SUBJECT: ISSUANCE OF AMENDMENTS - MCGUIRE NUCLEAR STATION, UNITS 1 AND 2
(TAC NO. M82340)

AMENDMENT NO. 130 TO FACILITY OPERATING LICENSE NPF-9 - McGuire Nuclear
Station, Unit 1

AMENDMENT NO. 112 TO FACILITY OPERATING LICENSE NPF-17 - McGuire Nuclear
Station, Unit 2

ATTACHMENT TO LICENSE AMENDMENT NO. 130

Figure 2.1-1 Reactor Core Safety Limits -
Four Loops in Operation

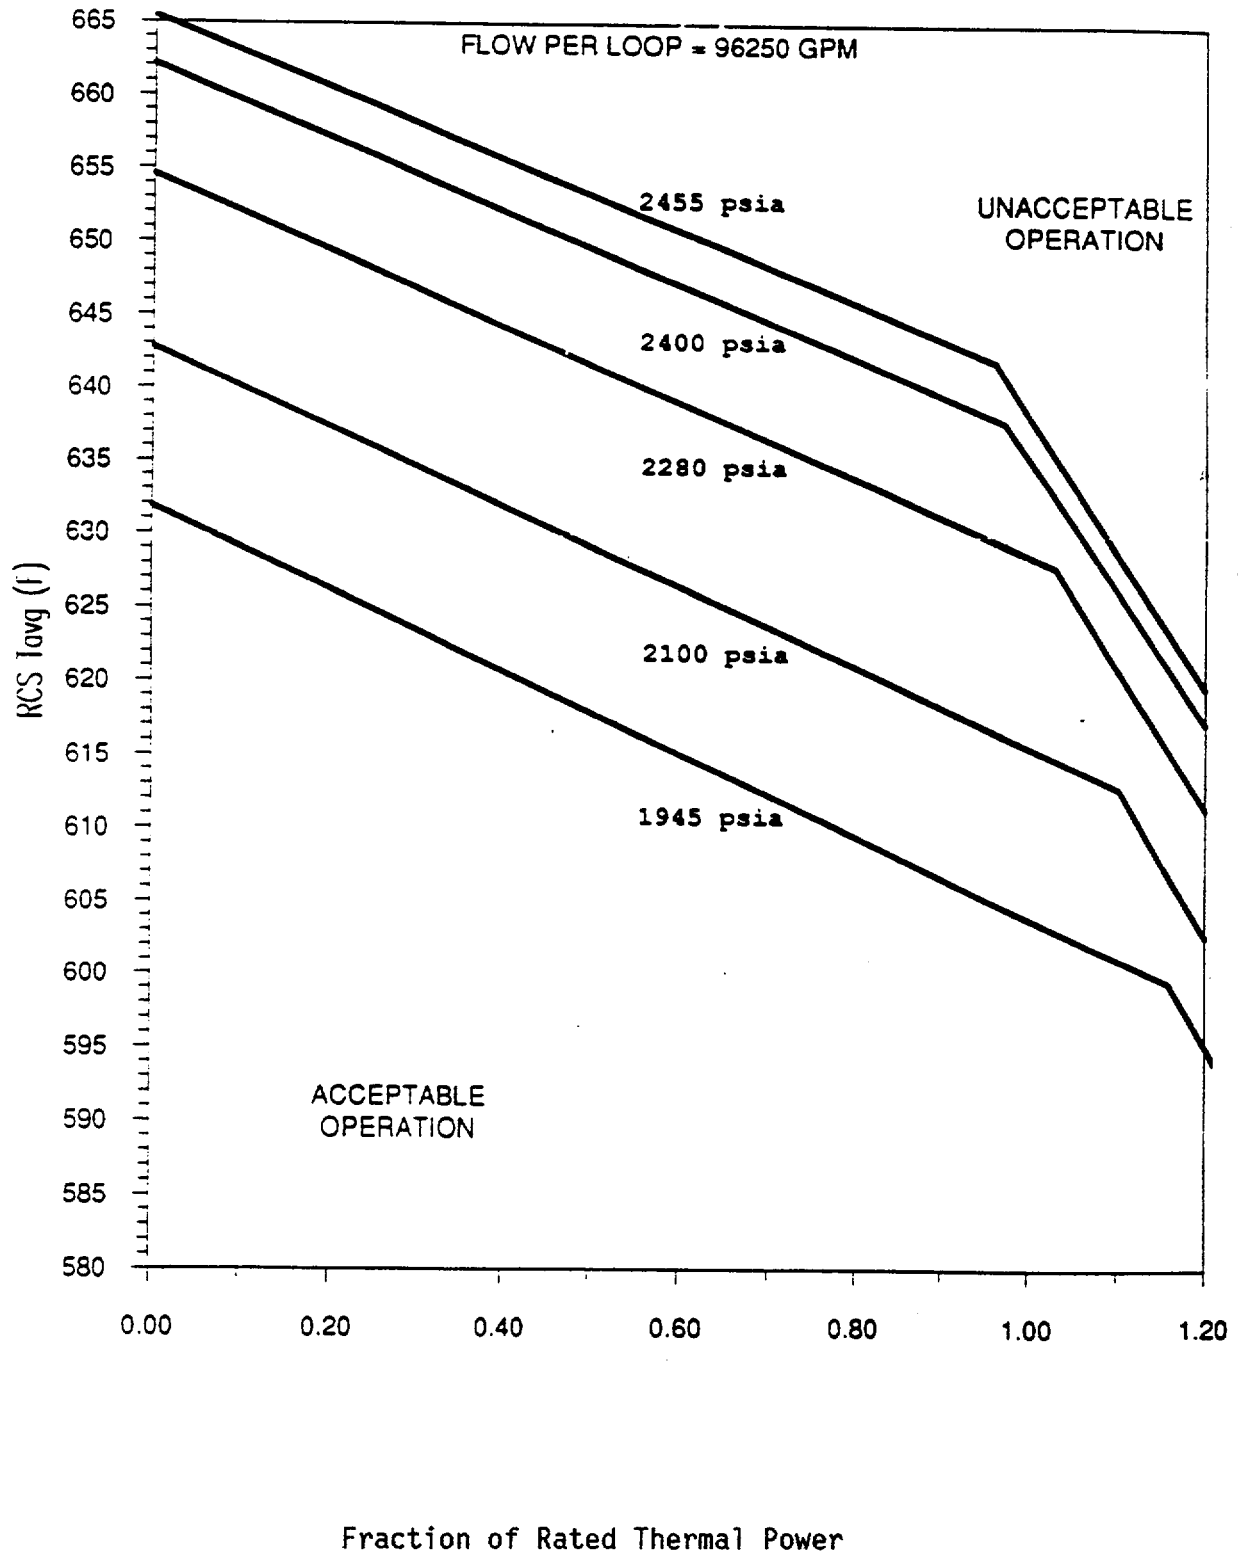
2.1.1 The combination of THERMAL POWER, pressurizer pressure, and the highest operating loop coolant temperature (T_{avg}) shall not exceed the limits shown in Figures 2.1-1 and 2.1-2 for four and three loop operation, respectively.

The curves of Figure 2.1-1 show the loci of points of THERMAL POWER, Reactor Coolant System pressure, and average temperature below which the calculated DNBR is no less than the design DNBR value or the average enthalpy at the vessel exit is less than the enthalpy of saturated liquid.

Figure 3.2 - 1. Reactor Coolant System Total Flow Rate Versus Rated Thermal Power - Four Loops in Operation

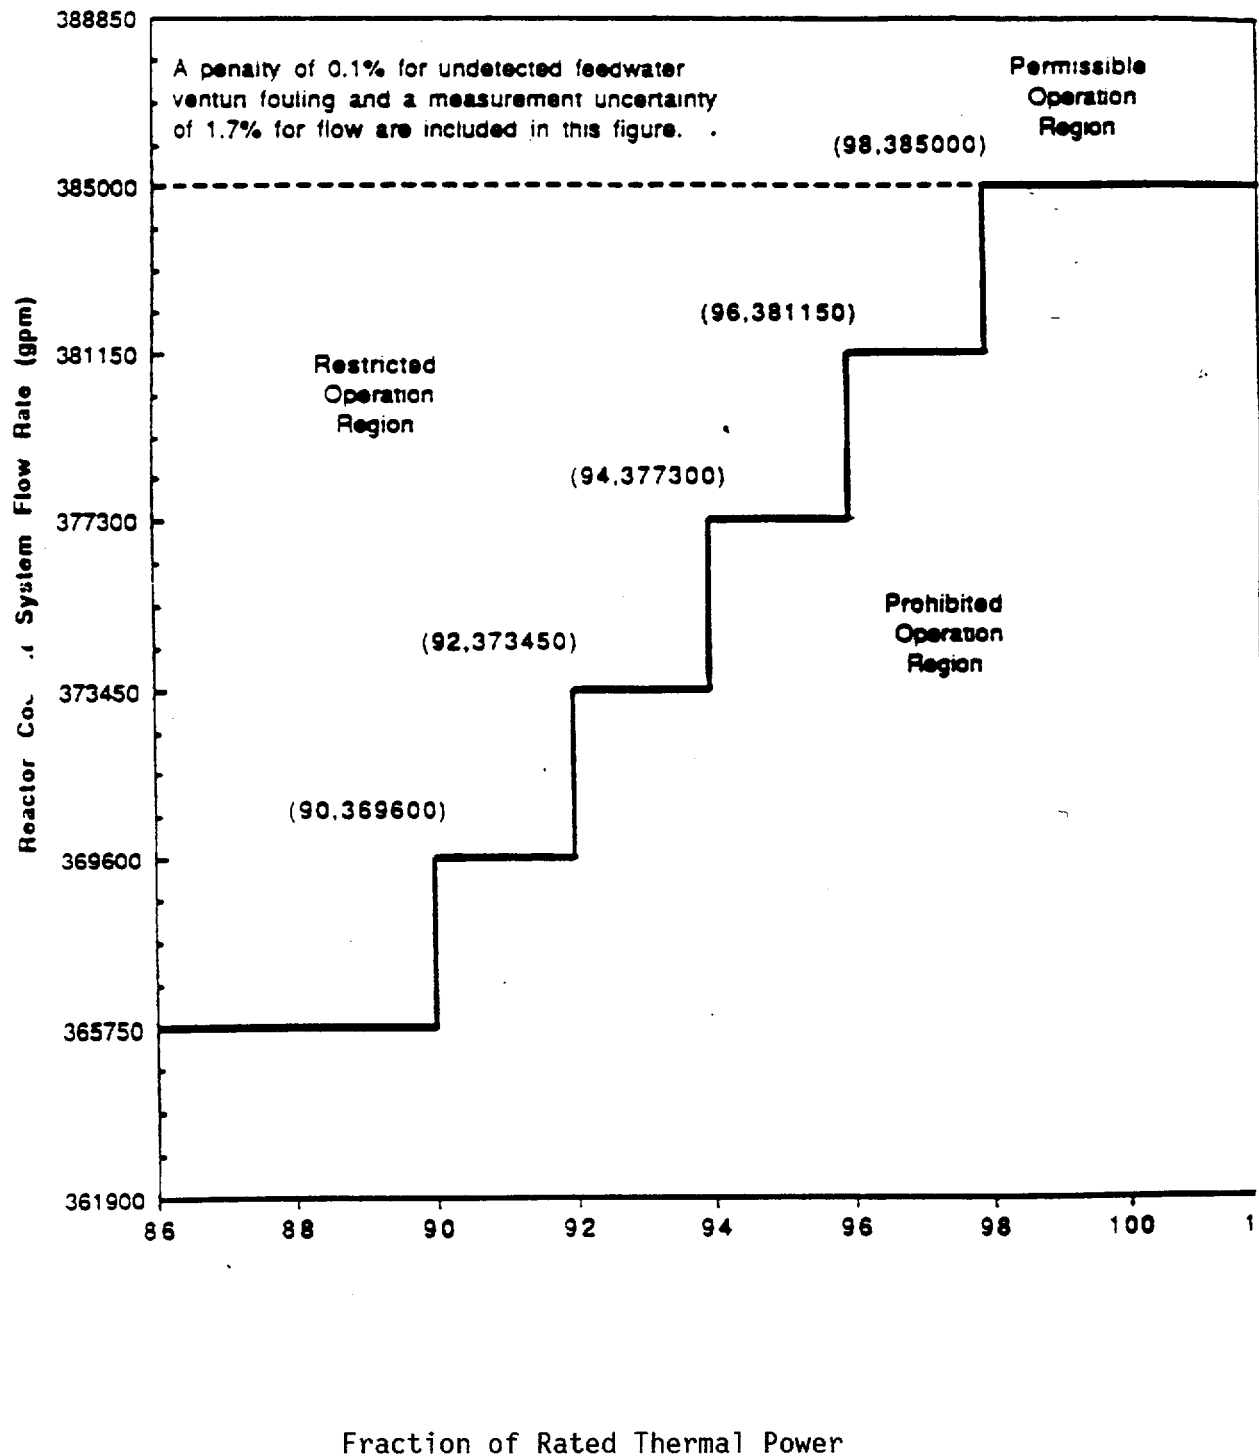
- b. With the combination of Reactor Coolant System total flow rate and THERMAL POWER within the region of restricted operation specified on Figure 3.2.1, within 6 hours reduce the Power Range Neutron Flux-High Trip Setpoint to below the nominal setpoint by the same amount (% RTP) as the power reduction required by Figure 3.2-1.

- c. With the combination of RCS total flow rate and THERMAL POWER within the region of prohibited operation specified on Figure 3.2-1:
 1. Within 2 hours either:

manner. Therefore, a penalty of 0.1% for undetected fouling of the feedwater venturi is included in Figure 3.2-1. Any fouling which might bias the RCS flow rate measurement greater than 0.1% can be detected by monitoring and trending various plant performance parameters. If detected, action shall be taken before performing subsequent precision heat balance measurements, i.e., either the effect of the fouling shall be quantified and compensated for in the RCS flow rate measurement or the venturi shall be cleaned to eliminate the fouling.
